Office Action Summary

09/615,875

TANAKA, HIDEAKI

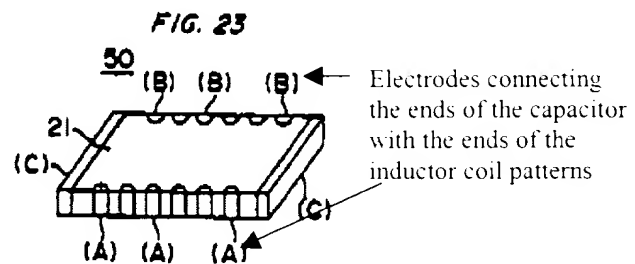
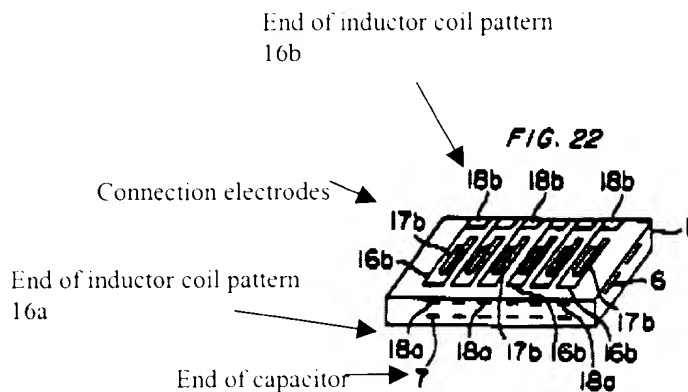
The primary reference Senda et al teaches a circuit comprising of plurality (six) inductor coil patterns (16a 16b) in a multilayer laminated structure wherein the multilayer laminated

structure comprises a plurality of ceramic sheets produced by mixing a dielectric material power with a resin binder. The inductor coil patterns are connected to each other via connection electrodes (17a 17b). The inductor coil patterns are arranged on the same plane and have same shape. The inductor coil patterns are parallel to the layer in the laminated structure. The first inductor coil patterns (16a) are wound in the opposite direction to the winding of the other inductor coil patterns (16b). The circuit also comprises a three plurality (fourteen) of capacitors (5 6 7). The number of capacitor is greater than the number of inductors. The inductor and capacitor circuit have a π configuration and are used a π type noise (low pass) filters. One of the plurality of capacitors (7) is connected to an end of the plurality inductors (16a), and another of the plurality of capacitors (5) is connected to another end of the plurality inductors (16b), are located at different positions in a laminating direction of the insulating layers. (Figures 18-24 and column 6, line 5 through column 7 line12)

Thus, Senda et al is shown to teach all the limitations of the claim with the exception of the inductors and the capacitor comprising at least four stages of a low pass filter.

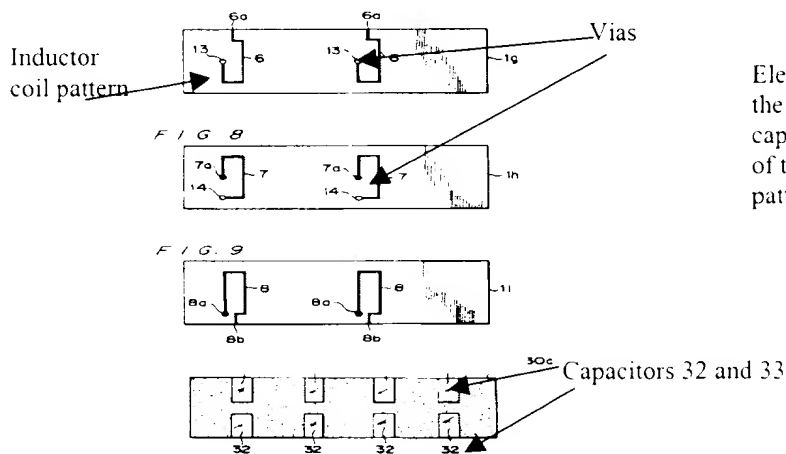
The primary reference, Okubo teaches a circuit comprising of plurality (four) inductor coil patterns (21a 21b) in a multilayer laminated structure wherein the multilayer laminated structure comprises a plurality of dielectric layer (30a 30d) and a magnetic layer (1a-1i). The inductor coil patterns are connected to each other through vias (11 12 13 14). The inductor coil patterns are arranged on the same plane and have same shape. The inductor coil patterns are parallel to the layer in the laminated structure. The first inductor coil patterns (2) are wound in the opposite direction to the winding of the other inductor coil patterns (3). The circuit also comprises a plurality of capacitors (32 33). The number of capacitor is greater than the number of inductors. The inductor and capacitor circuit have a π configuration and are used a π type noise (low pass) filters. In figure One of the plurality of capacitors is connected to an end of the plurality inductors, and another of the plurality of capacitors is connected to another end of the

plurality inductors, are located at different positions in a laminating direction of the insulating layers. (Figures 1-9 and 13-18 and column 2 line 23 through column 3 line 67)

Thus, Okubo is shown to teach all the limitations of the claim with the exception of the inductors and the capacitor comprising at least four stages of a low pass filter.

Electrodes connecting the ends of the capacitor with the ends of the inductor coil patterns

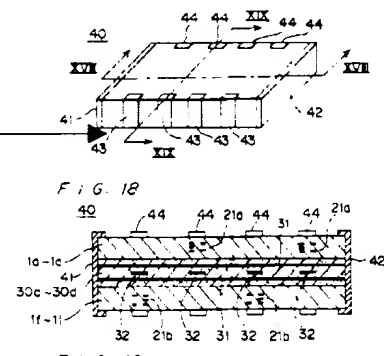
Golant et al discloses in figure 1, a low pass filter wherein the inductors and capacitor make of the stage of the filter. (Figure 1 and column 1 line 61 through column 2 line 18)

One skilled in the art at the time of the invention would have found it obvious to connect the ends of the inductors of Okubo in the circuit configuration of Golant et al in order make a low pass filter.
